**BOARD ACTION REPORT – APPEALABLE ITEM**

**Project Name:** The Flossy Building  
**Project Location:** 124 NE 5<sup>th</sup> Avenue  
**Request:** Class V Site Plan  
**Board:** Site Plan Review and Appearance Board (SPRAB)  
**Meeting Date:** March 9, 2016

# SITE PLAN REVIEW AND APPEARANCE BOARD

**ITEM:** **The Flossy Building** - Class V Site Plan, Landscape Plan and Architectural Elevations associated with demolition of the existing site and construction of a new 2-story mixed-use development with 6,540 sq. ft. of retail on the ground level and residential on the upper levels. (124 NE 5<sup>th</sup> Avenue)

Architectural Site Plan

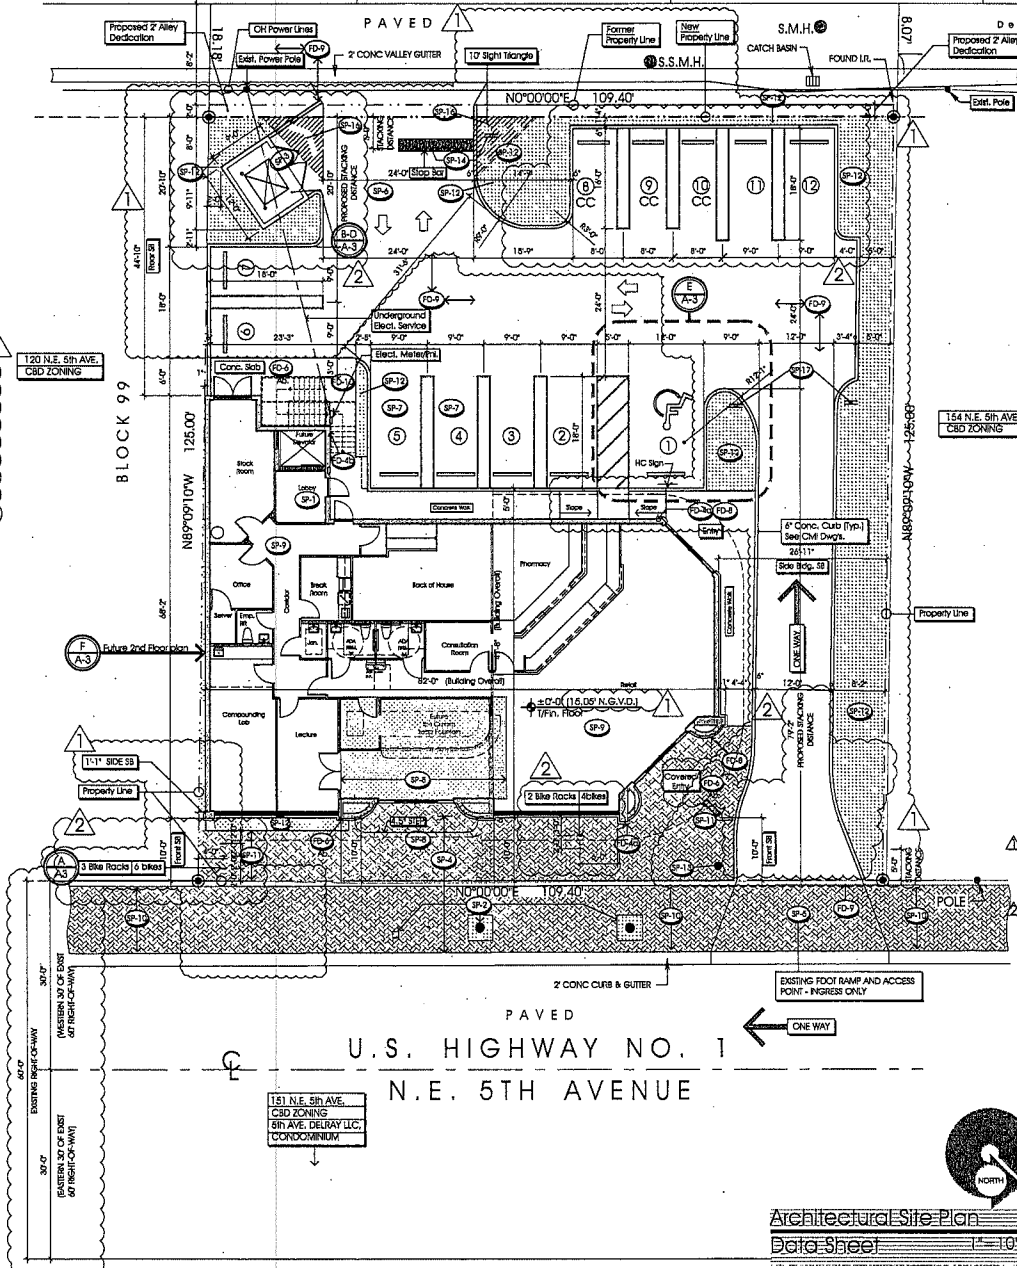
Since the current location and position the proposed dumpster enclosure may potentially conflict with ingress and egress from the two-way 24' drive aisle, provision of a truck turning template to demonstrate how the dumpster truck will maneuver in and out of the alleyway to accommodate regular trash pick-up is requested. Pursuant to LDR Section 4.6.6(C)(1), dumpsters, recycling containers and similar service areas must be enclosed on three (3) sides with vision obscuring gates on the fourth side, unless such areas are not visible from any adjacent public right-of-way. The dumpster detail indicates that this requirement has been met. However, provision of the dumpster truck detail is attached as a condition of approval. Upon doing so, this LDR requirement will be met.

1. Civil plans shows an existing utility pole in alley, please indicate plans to relocate out of traffic area.
2. Clearly indicate limits of alley restoration in 2' area to be dedicated.

1. Provide revised civil drawings which satisfy the preliminary engineering technical comments identified in the attached "Appendix C", prior to site plan certification.
2. Pursuant to Section 6.1.8 (Undergrounding of Utilities), utility facilities serving the development (i.e. electric, phone, cable) shall be located underground throughout the development. Therefore, the utility services for the proposed structure must be placed underground and a note to this effect shall be included on the proposed site plan. This shall replace the current note "All existing underground utilities to be left undisturbed as noted", prior to certification of the site plan.
3. Since the current location and position the proposed dumpster enclosure may potentially conflict with ingress and egress from the two-way 24' drive aisle, provision of a truck turning template to

demonstrate how the dumpster truck will maneuver in and out of the alleyway to accommodate regular trash pick-up is required, prior to certification of the site plan.

Front Elevation (East) 1/4" SC

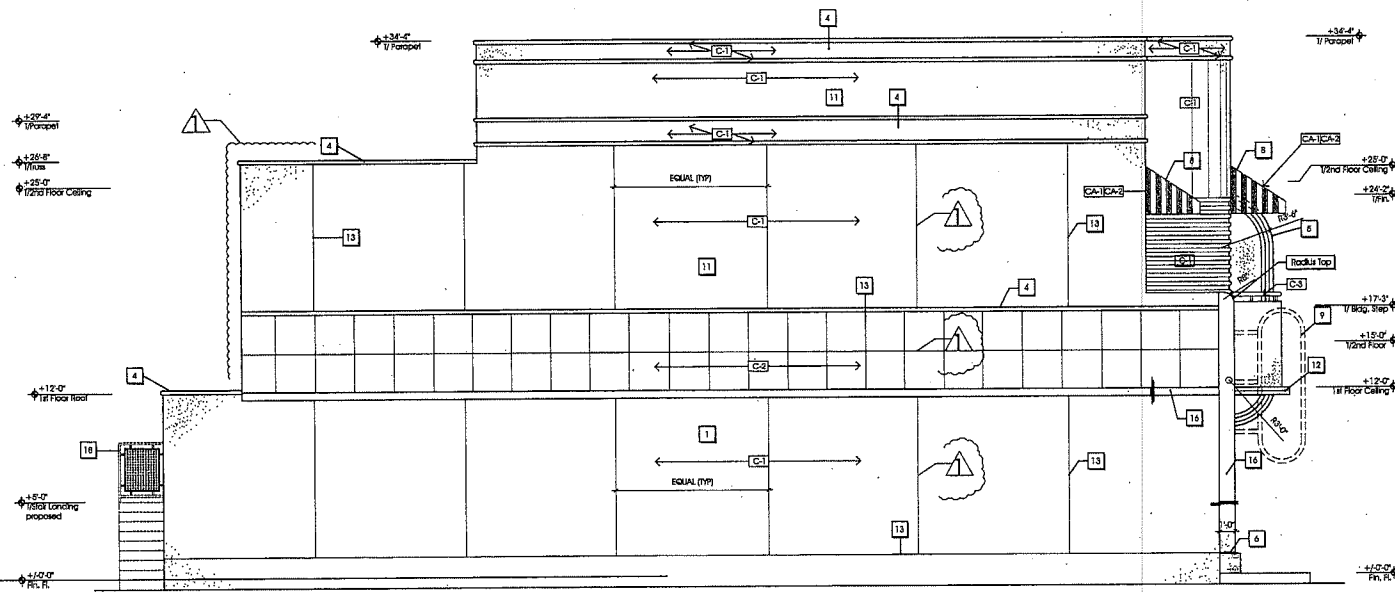
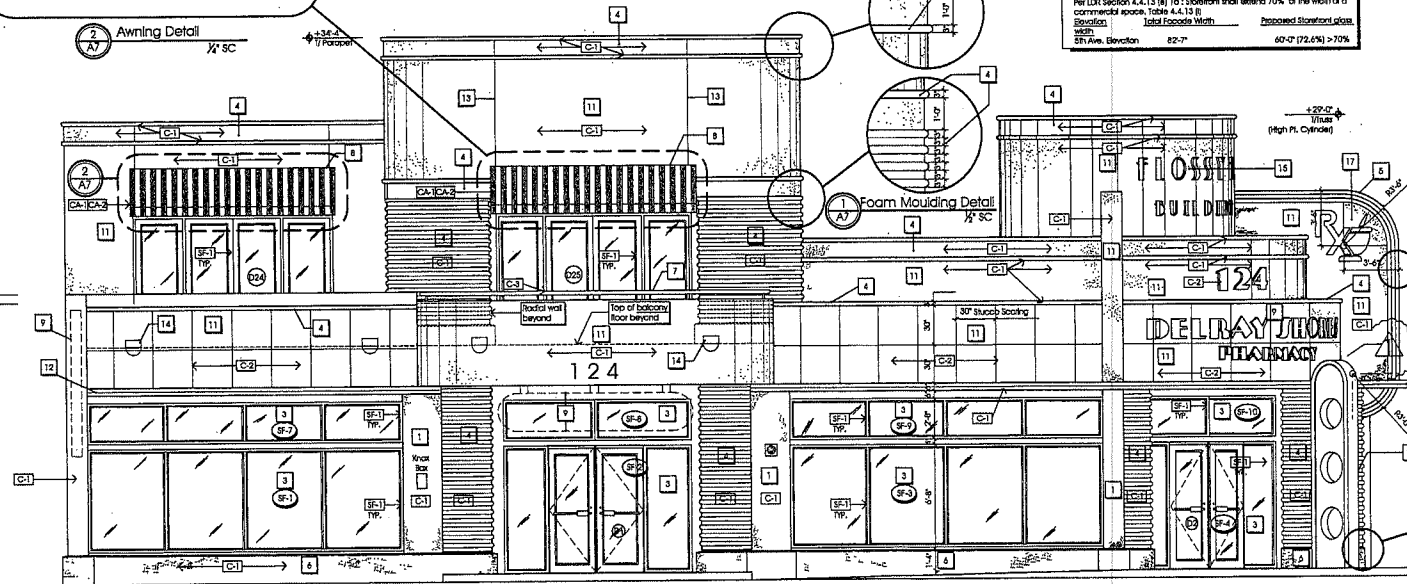
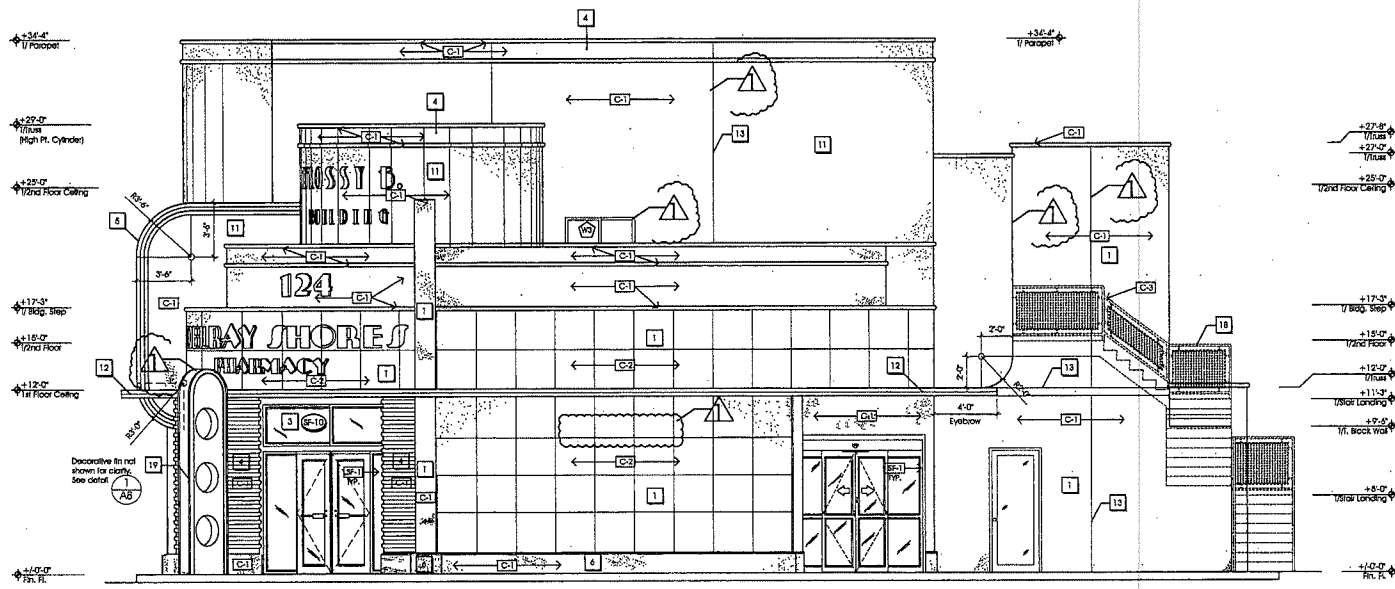
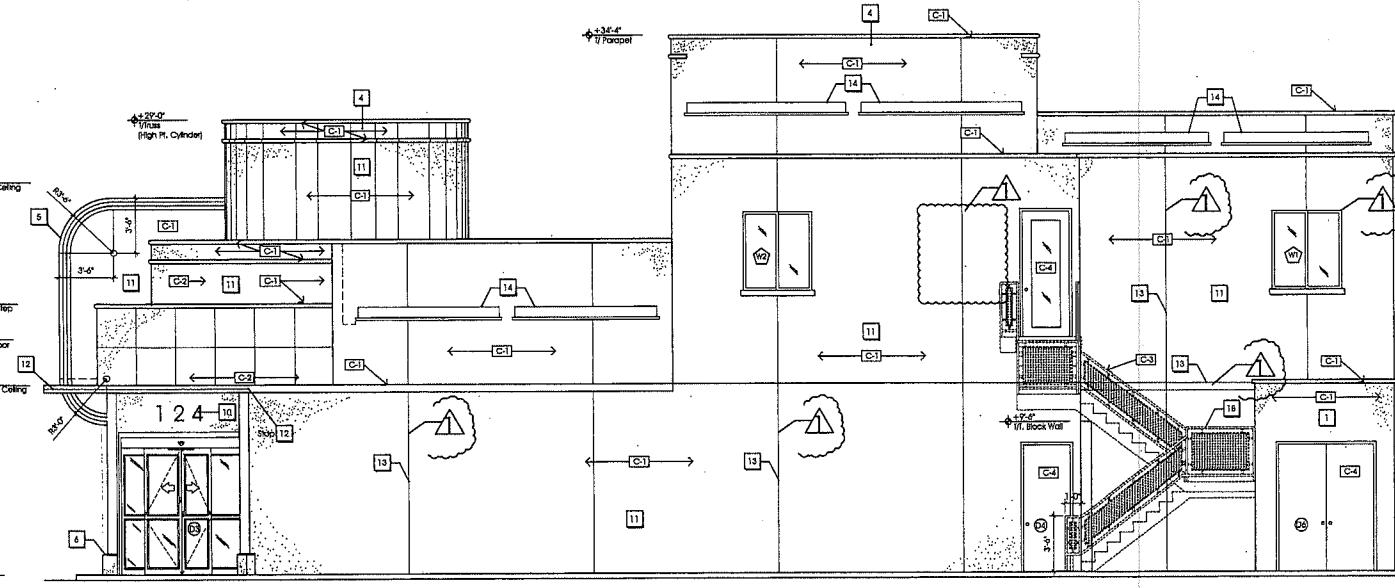
Staff did not recommend approval of the “foam moulding” building material proposed for the architectural elevations and asked that it be substituted with an alternate material that exhibited a similar design or visual effect and has long term durability. The applicant brought a “Stone Cast” building material sample to the meeting for the Board’s consideration. The Board deemed the substitution acceptable.

While it is not explicitly stated in the most recent updates to the LDRs and architectural guidelines, ongoing discussion regarding the discouragement, and potential prohibition of "foam moulding" continues, due to its lack of long term durability. As such, staff is recommending that this feature element be modified to reflect stucco banding or an alternate material to produce the desired visual effect proposed by the "foam moulding". This is a staff recommendation that is at the Board's discretion. However, it is recommended as a condition of approval for the proposed architectural elevations.

styles in the CBD Zoning District. However, staff does not support the use of foam moulding and requests that this feature element be replaced with a more durable but equally aesthetic architectural element. The mixed-use development will be consistent with the current policies and objectives of the Comprehensive Plan and Chapter 3 of the Land Development Regulations, subject to the conditions as indicated in the staff report. Therefore, positive findings can be made with respect to Section 2.4.5(F)(5).

1. Replace the “foam moulding” with an alternate material or design that exhibits a similar visual effect (i.e. stucco banding) and has long term durability. This feature element is not preferred and is inconsistent with the recently established CBD architectural design guidelines.
